WILLIAMSON COUNTY, TEXAS

CHANGE ORDER NUMBER: 1

CR 138 Right Turn Lane at SH 130 Williamson County Project No. 24IFB19

Change Order No. 1

SE LOOP SEGMENT 1 PHASE 1
 RETAINING WALL
 LAYOUT
 WALL2

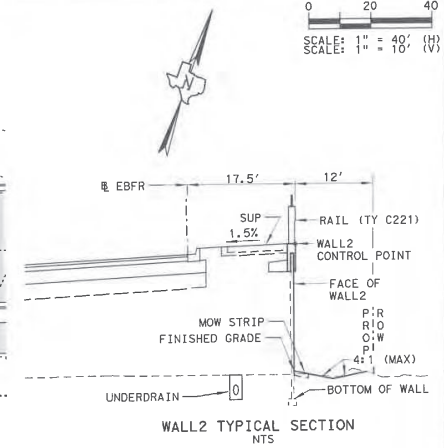
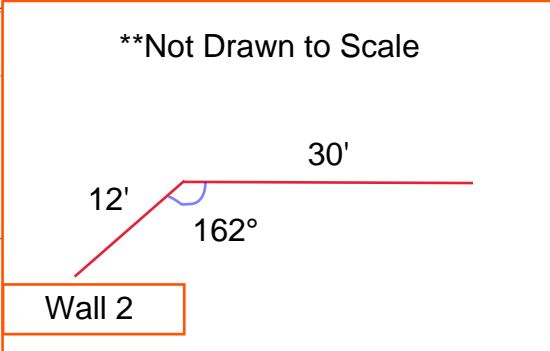
The handrail will be a total of 42 LF with a 1' x 1' footing poured monolithically with the SUP. A more precise drawing of the handrail is shown to the right. There will be roughly 2-3" between the face of Wall 2 and the end of the new handrail.

PROPOSED S4

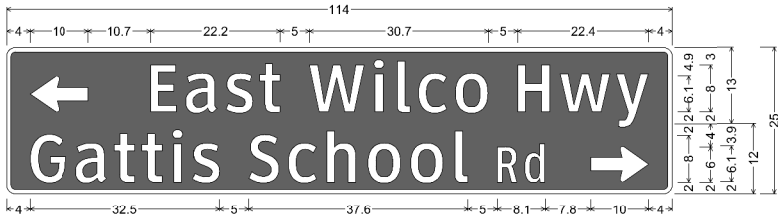
REMOVE AND REPLACE EXISTING SIGN

PROPOSED S5

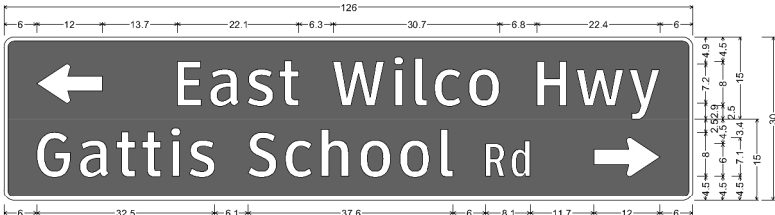
REMOVE AND REPLACE EXISTING
SIGN. NEW SIGN LOCATION - SEE
SUMMARY OF SMALL SIGNS.

PROPOSED S6

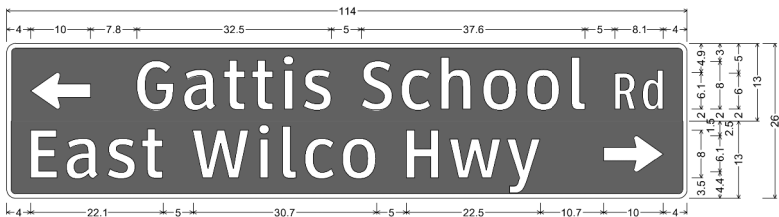
REMOVE AND REPLACE EXISTING SIGN

PROPOSED S7

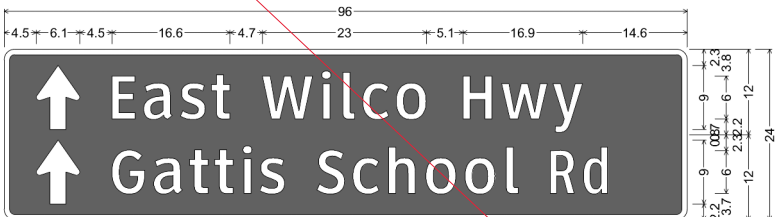
REMOVE AND REPLACE EXISTING
SIGN. NEW SIGN LOCATION - SEE
SUMMARY OF SMALL SIGNS.

PROPOSED S11

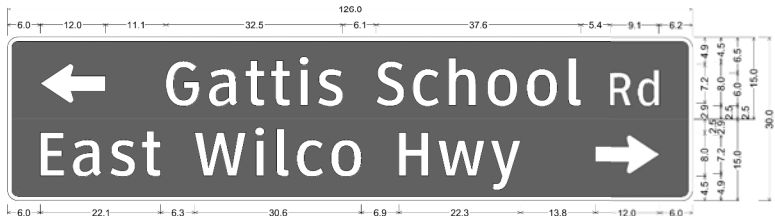
REMOVE AND REPLACE EXISTING
SIGN.

PROPOSED S4

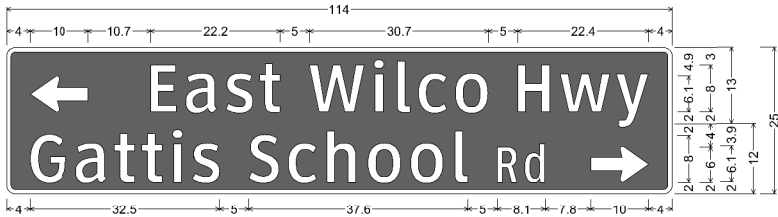
REMOVE AND REPLACE EXISTING SIGN

PROPOSED S5

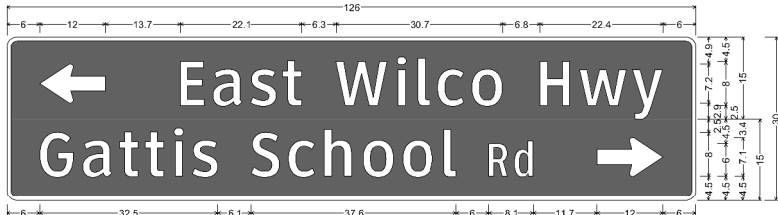
REMOVE AND REPLACE EXISTING
SIGN. NEW SIGN LOCATION - SEE
SUMMARY OF SMALL SIGNS.

PROPOSED S6

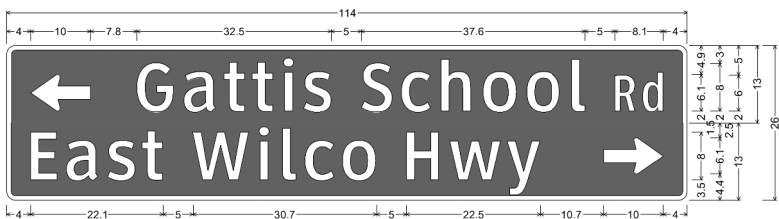
REMOVE AND REPLACE EXISTING SIGN

PROPOSED S7

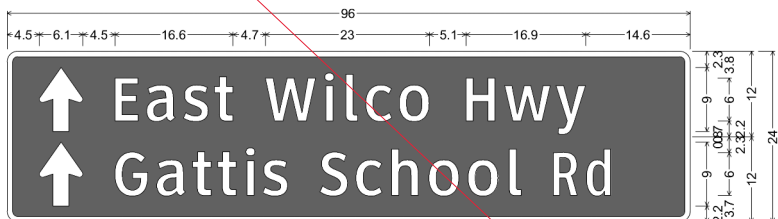
REMOVE AND REPLACE EXISTING
SIGN. NEW SIGN LOCATION - SEE
SUMMARY OF SMALL SIGNS.

PROPOSED S11

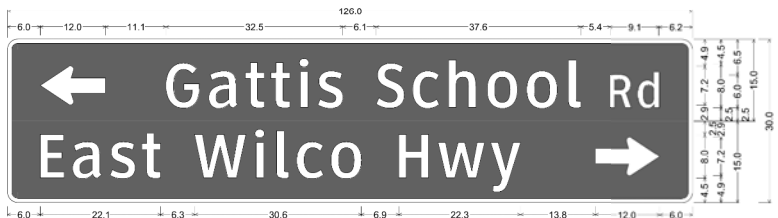
REMOVE AND REPLACE EXISTING
SIGN.
